## Fitzsimons Building 3<sup>rd</sup> Floor Elevator Lobby Lighting

Project Number – 22-154559

### ADDENDUM 1

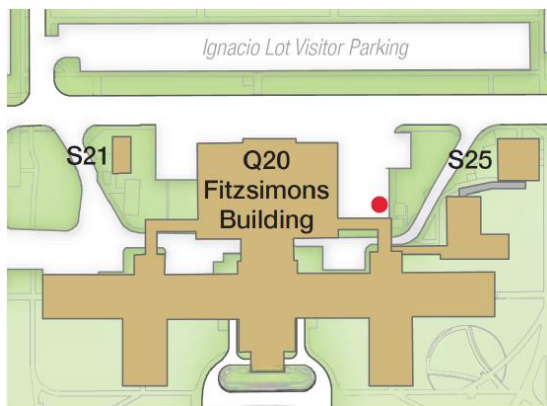
4. Please clarify if the \$19,000 allowance includes drywall patch and repair. Same question for Sheet notes 2 on sheet E2.0 of the CD set.

**Response:** Yes, the \$19,000 allowance will include all items associated with the replacing ceiling tile scope and painting corridor scope. For the purpose of the bid, all bidders to carry the \$19,000 as part of their total bid price. Contractor is responsible for protecting all existing conditions as necessary to prevent damages.
